# UNITED STATES DEPARTMENT OF THE INTERIOR BUREAU OF LAND MANAGEMENT

## Delaware Basin in Eddy County

# Changes to APD FOR Federal Wells Batch Drill

HH SO 10 15 FED 002	6H	30-015-44367
HH SO 10 15 FED 002	5H	30-015-44371
HH SO 10 15 FED 002	4H	30-015-44353
HH SO 10 15 FED 002	3H	30-015-44351
HH SO 10 15 FED 002	2H	30-015-44354
HH SO 10 15 FED 002	1H	30-015-44352

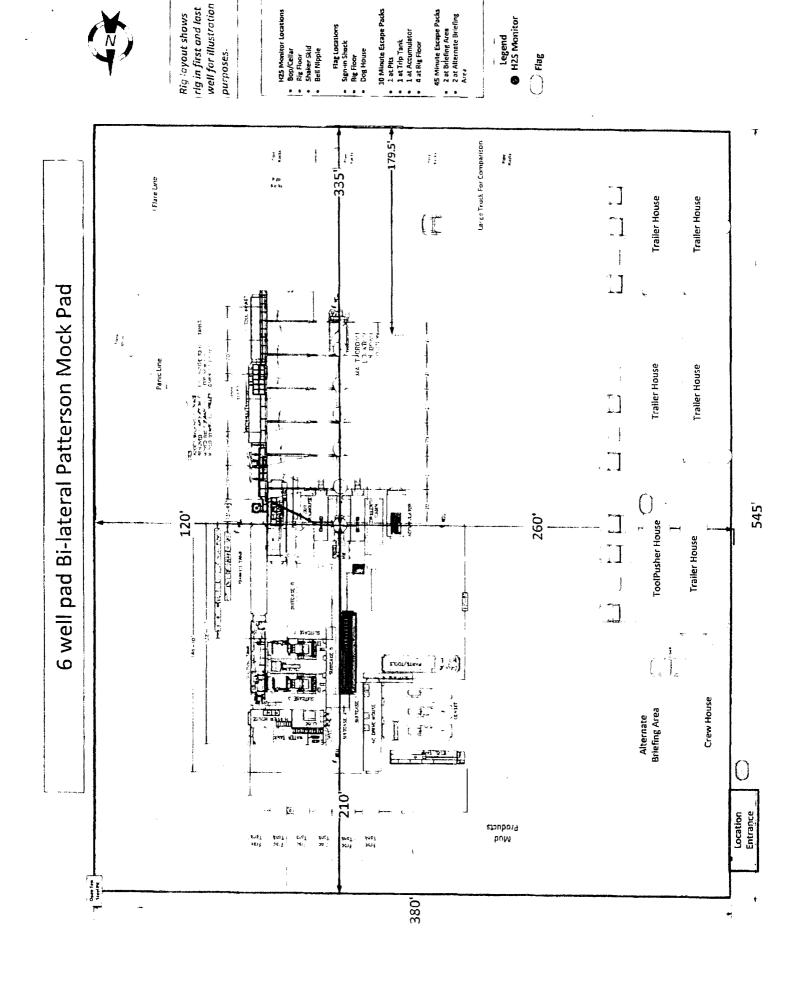
- 1. Drill 17-1/2" surface hole with fresh water to planned casing set depth with 10' rat hole.
- 2. Run casing as stated by approved APD, land out wellhead, and cement.
- 3. Dress out 13-5/8" 5M SH-2 wellhead and install/secure with temporary abandonment cap and a pressure gauge will be installed. Reference image below Part U 399984.
- 4. Skid to next well according to below "Drill Order".
